HAMILTON COUNTY

### STAFF REPORT

**ANDERSON 2021-01**

## **BEECHMONT & KING LOUIS COURT**

# SITE PLAN

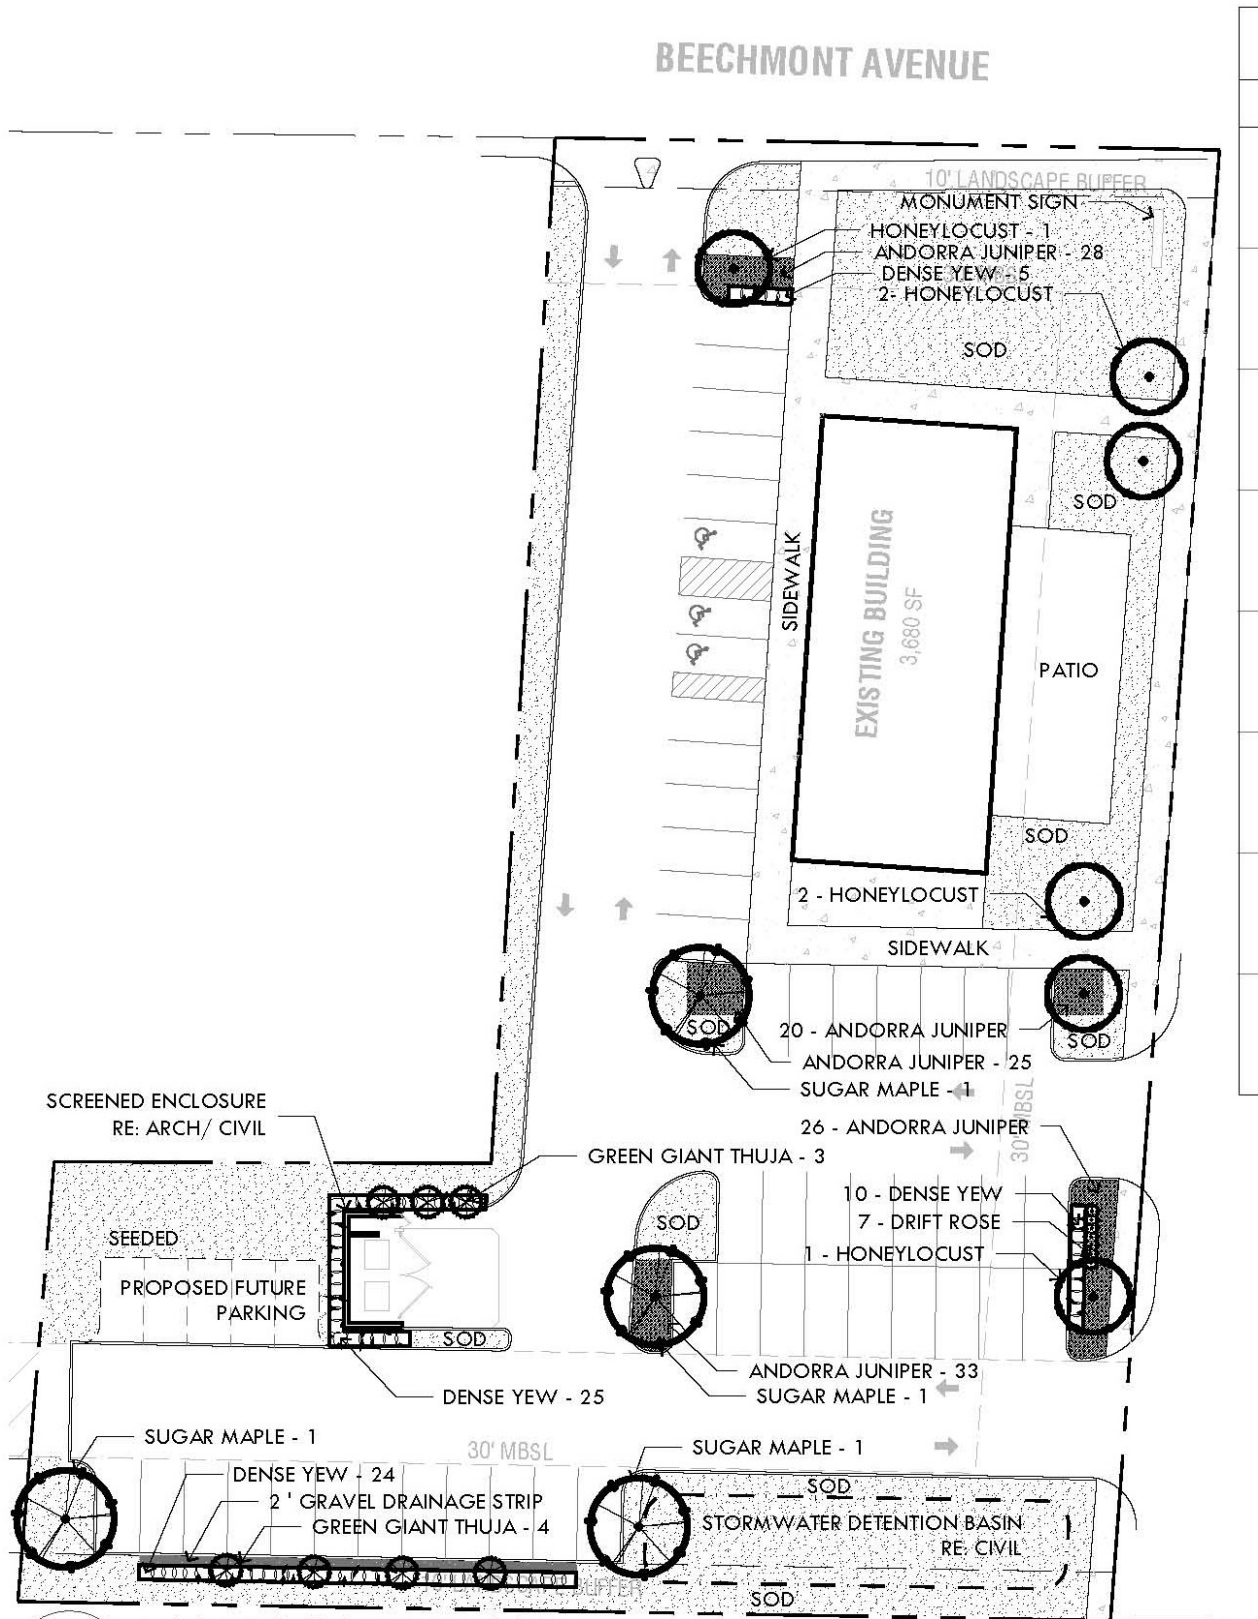
- *The applicant has not identified the 60 feet from the centerline of Beechmont Avenue. It appears that there is sufficient space on the property to dedicate the required right-of-way without significant impacts on the proposed development plan. Therefore, staff finds that the applicant should revise the plan to identify the required right-of-way per the Hamilton County Thoroughfare Plan.*

**Findings:** *Staff finds that the existing building is located more than 30 feet from both Beechmont Avenue and King Louis Court. It also appears that the building would still be setback 30 feet from Beechmont Avenue once additional right-of-way is provided. However, there appears to be a shade structure over the outdoor seating area that would be located 10 feet from the King Louis Court right-of-way. Staff supports a reduced setback in this location as it is located on a side street and would provide an amenity to the outdoor patio proposed for the site provided that the outdoor dining area remains open air and is not enclosed in the winter months. An enclosed structure this close to the right-of-way would be imposing and there are no other structures that close to the right-of-way on the other side of the street. Reducing the setback to 10 feet would still allow space for the required sidewalk to be constructed along this section of King Louis Court.*

**Findings:** *The proposed plan indicates the required parking space boundary landscaping but does not include any landscaping in the portion of the parking lot adjacent to the detention basin. This portion of the parking would not be screened from the residential apartments to the south and lights from vehicles parking in the area north of the detention basin would shine directly on the property to the south. Additionally, there is no screening adjacent to the parking lot to the west of the southernmost row of parking. A single-family home is located to the west of this portion of the lot and the lack of screening here would also allow lights from vehicles to shine directly on the adjacent property to the west. Staff finds that landscaping or fencing should be added to the entire southern property line and the portion of the western property line adjacent to the single-family property to the southwest to comply with this section of the Zoning Resolution.*

**Findings:** *The proposed plan includes 5 spaces along the 2 entry drives from King*

*Louis Court that are less than 30 feet from the right-of-way. Additionally, if the required right-of-way dedication is provided on the Beechmont Avenue frontage, there would be 3 more parking spaces that would not meet this requirement. Staff finds that the plan should be revised to meet the required setback to limit the risk of cars backing out onto Beechmont Avenue or King Louis Court.*

**Findings:** *The submitted lighting plans shows an area exceeding 0.10 footcandles on the adjacent single-family property to the southwest. Staff finds that the plan should be revised to comply with this section of the Zoning Resolution.*

The applicant has not submitted a sign plan. The submitted site plan indicates a “restaurant sign” that would be a freestanding sign at the intersection of Beechmont Avenue and King Louis Court. This is the general location of the existing sign for the automotive use that would be replaced by the restaurant. It is unclear if the applicant intends that the existing sign be maintained and refaced for the restaurant or if this would be a new sign. Either way, the sign is currently located in the vision clearance area of this intersection required by Section 5.5(C)(5) and would be well within the right-of-way of Beechmont Avenue after dedication per the Thoroughfare Plan. Staff finds that this sign should be removed and replaced with a new sign that complies with the requirements of the Zoning Resolution.

1. That the plan shall be revised to comply with the requirements of the Hamilton County Thoroughfare Plan.
2. That a landscape plan in accordance with the Zoning Resolution, and with

- Condition #3 below, shall be submitted as part of the Final Development Plan.
3. That additional streetscape elements, including but not limited to trees, shrubs, low walls, benches, and trash cans, shall be provided along the Beechmont Avenue frontage of the property and shall be submitted as part of the Final Development Plan.
  4. That a lighting plan that meets the minimum standards of the Zoning Resolution shall be submitted as part of the Final Development Plan.
  5. That the parking lot shall be redesigned to provide a minimum 30-foot setback for all parking spaces from the right-of-way of Beechmont Avenue and King Louis Court in accordance with the Zoning Resolution.
  6. That the existing freestanding sign on the property shall be removed and that any proposed building mounted or freestanding signage plans shall be submitted as part of the Final Development Plan.

1. Section 3.15(D)(2) – That the outdoor patio canopy shall be permitted to provide a 10-foot front yard setback from King Louis Court where a 30-foot front yard setback is required.

## ELEVATIONS

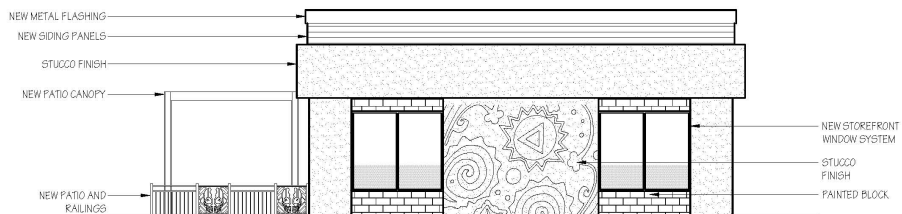
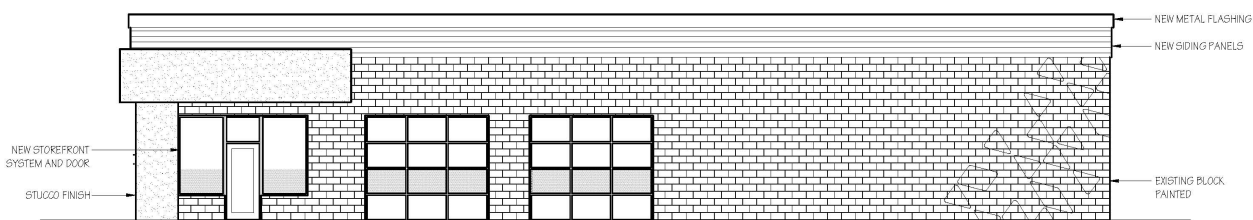
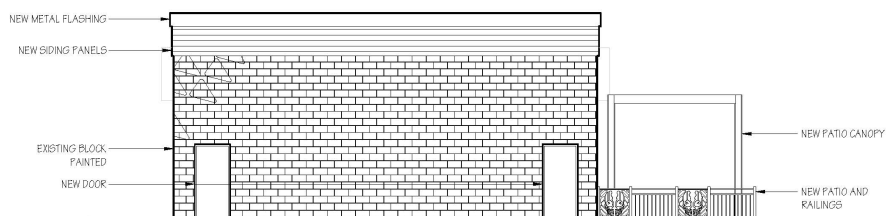
- *The submitted building elevations appear to provide a high-quality renovation that likely complies with the intent of the adopted plan for buildings in the corridor.*
